75	Policy	SFOB Project Number on all sheets and documents.	Architect	Will comply
76	Policy	All drawings at same level of completion.	Architect	Acknowledged
77	Policy	Roofing system submittal at DD.	Architect	Acknowledged
78	Policy	Provide requirements for Adjacent Ways Validation (i.e. single drawing and schedule of values).	Architect	Will provide
79	Policy	Composite site plan in a single file.	Architect	Acknowledged
80	Policy	HVAC in MDF or IDF rooms to be cooling only.	Mechanical Engineer	Will comply
81	Policy	Soil remediation (if required).	Architect, Civil	N/A
82	Policy	Verify if existing utilities are adequate for additional space: • Water supply • Waste / septic system • Gas supply • Electrical service	Mechanical Engineer, Electrical Engineer	Utilities connection on site. New site requiring Transformer, SES, etc.
83	Recommend	Rilem tubes test all exterior walls, including back of parapets or District Guideline exception form showing warranty & upgraded sealer criteria	Architect, Contractor Note: A letter from the coating contractor shall be provided as a required closeout document.	Acknowledged

SFOB DATA SHEET

SFB PROJECT #110220000-9999-037N

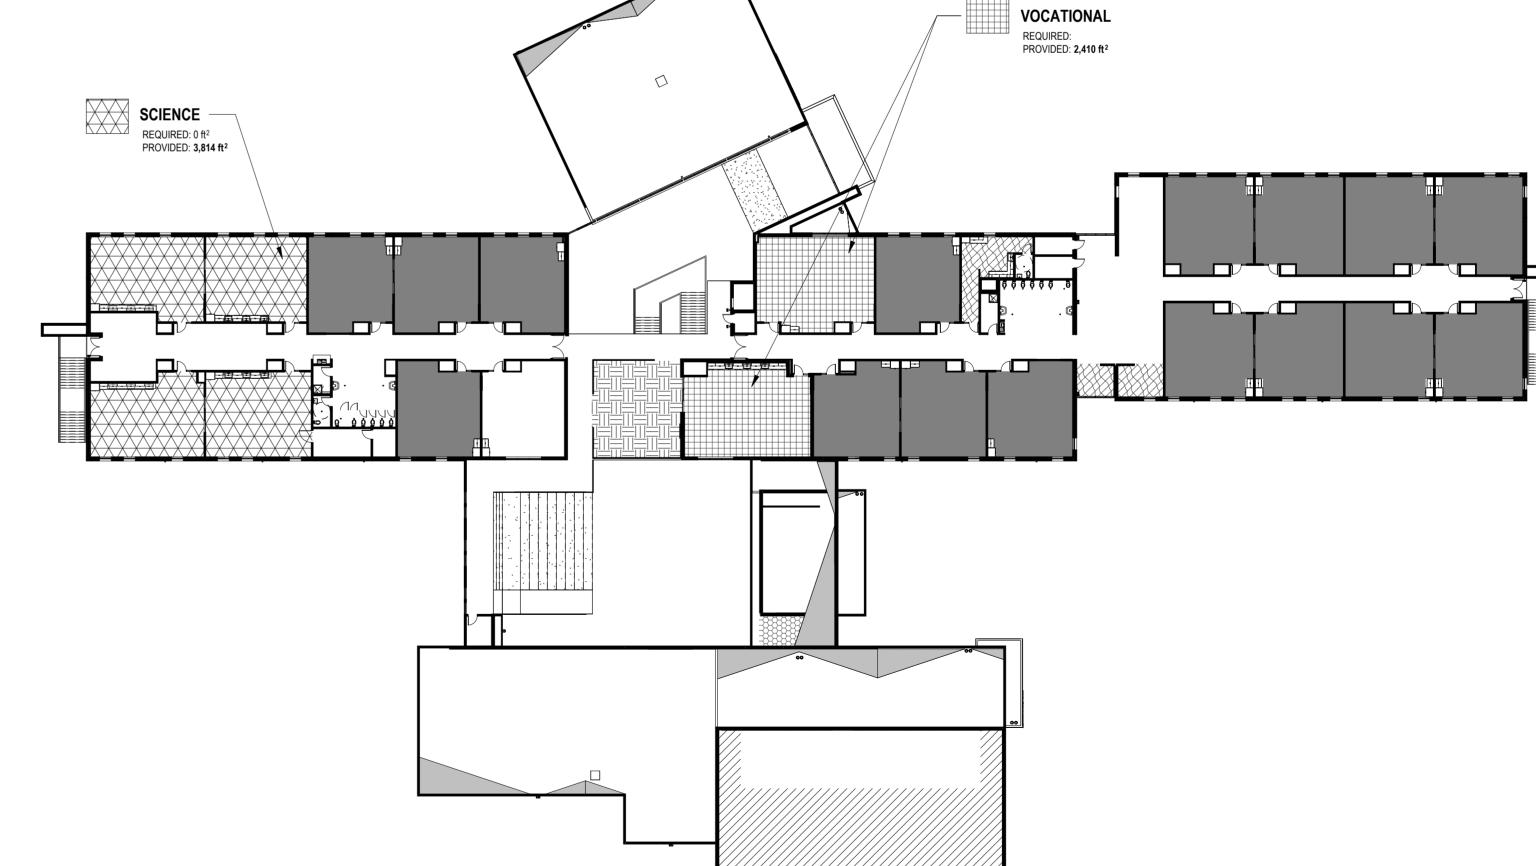
Note: SFOB recommends as established by Federal Property Management Regulations and the Arizona the District to consider supplies & furniture offered by the Surplus Property Management Office of the Arizona Department of SFOB This MAG Drawing Review Checklist is used SFOB by the SFOB NC Project Manager during their final walk through after a C of O is issued. Note: The District needs to

provide the SFOB occupied & unoccupied new classrooms so that classroom measurements can be made to verify MAG

compliance. See line items
